SUBJECT: **Safety Recall 12S37 - Supplement #1**
Certain 2001-2004 Model Year Escape Vehicles with 3.0L Engine and Speed Control
Engine Cover Modification

REF: **Safety Recall 12S37**
Dated July 26, 2012

New! REASON FOR THIS SUPPLEMENT

FIGURE 2

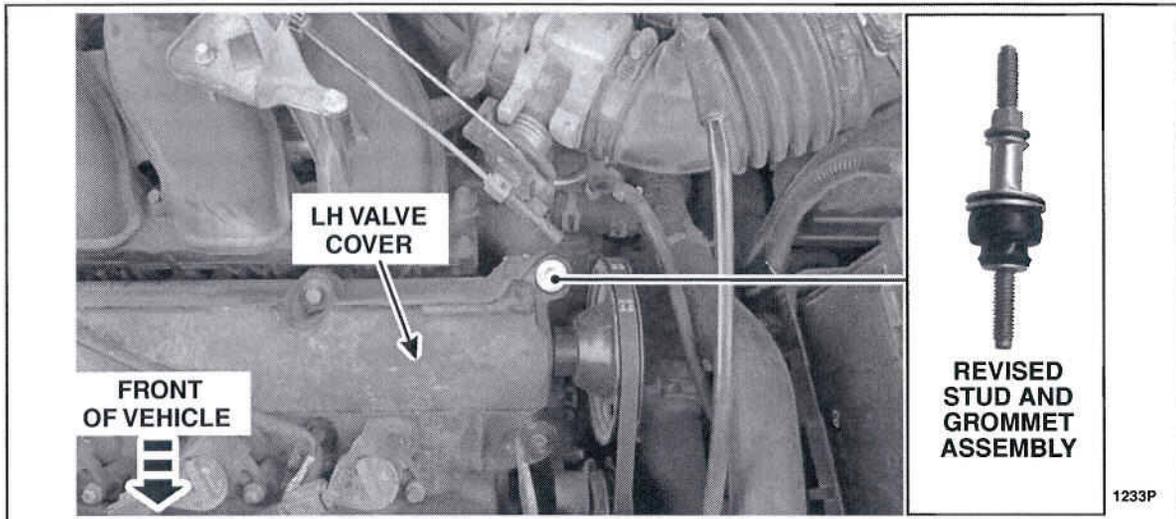
3. Remove the original rear stud and grommet assembly from the LH valve cover and install the *new* stud and grommet assembly. See Figure 2.

- Tighten the *new* stud and grommet assembly to 10 Nm (89 lb-in).

FIGURE 3

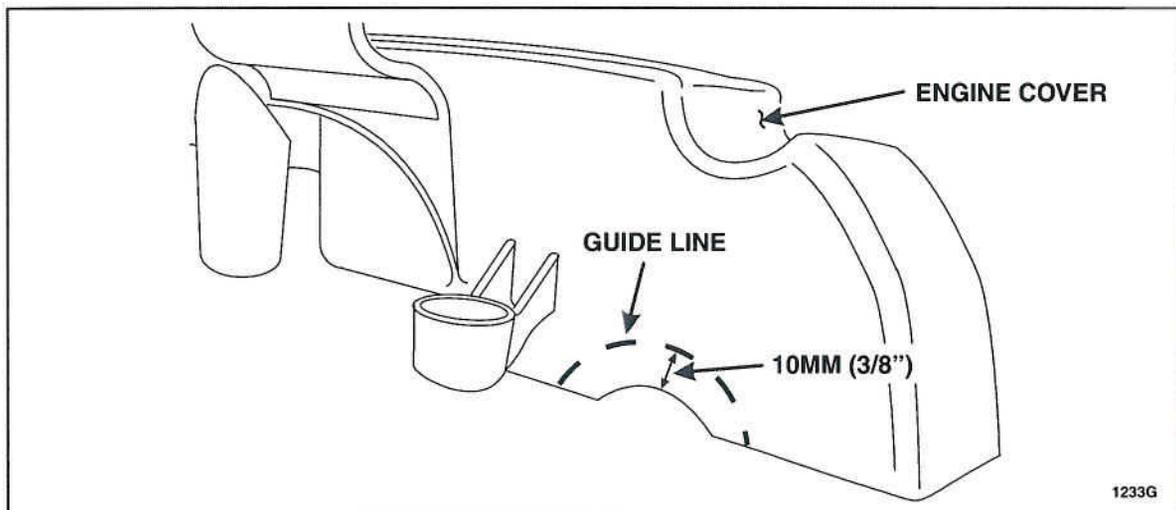
NOTE: The engine cover already has a relief to accommodate the drive belt tensioner. This relief needs to be trimmed to provide additional clearance.

4. Mark a guide line on the engine cover that is approximately 10mm (3/8") larger than the original opening. See Figure 3.

FIGURE 4

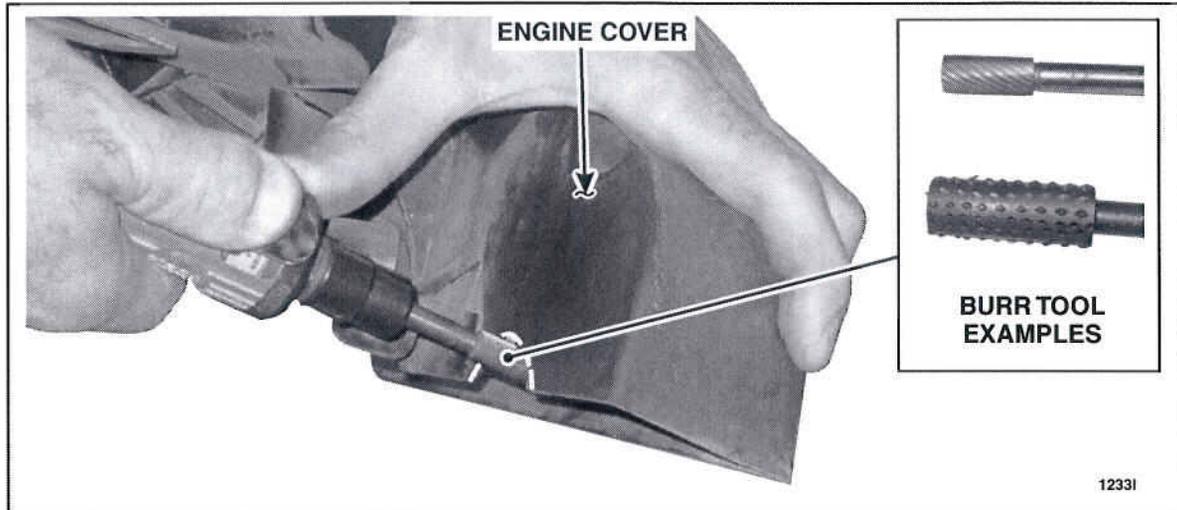
NOTE: Do not use hand tools or abrasive discs to cut the engine cover (hand tools will crack the engine cover and abrasive discs will melt the cover). Only high speed rotary burr tools should be used to modify the engine cover.

- Using a rotary burr tool, modify the engine cover by increasing the opening over the drive belt tensioner to the previously made guide line. See Figure 4.
